**PUBLIC FACILITIES REVIEW COMMITTEE MEETING**

**DATE:** December 18, 2013  
**TIME:** 7:00 p.m.  
**PLACE:** McKinley Elementary School Library  
1030 North McKinley Road

**Site Location:**  
McKinley Elementary School  
1030 North McKinley Road  
Arlington, VA 22205

**SUMMARY:** Arlington Public Schools (APS) is proceeding through the Building Level Planning Committee (BLPC) and the Public Facilities Review Committee (PFRC) processes for an addition and renovations to the McKinley Elementary School. The processes are in their conceptual stages, and major issues such as building placement, parking, and site circulation are currently being discussed.

Figure 1 - Existing Site Layout.

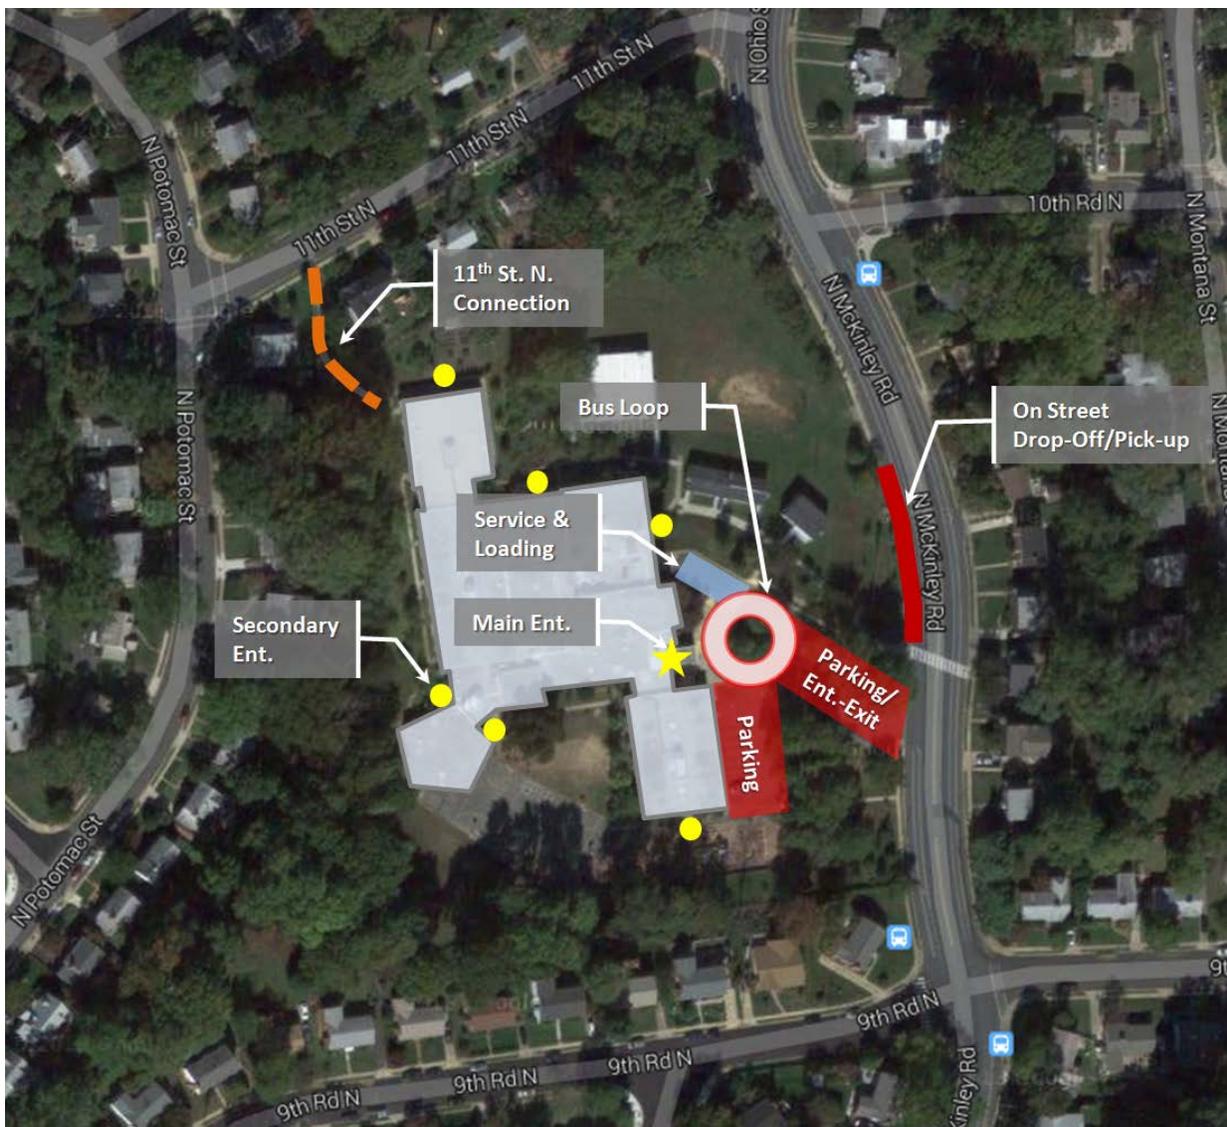
The current design alternatives under review would not significantly change site circulation from existing conditions.
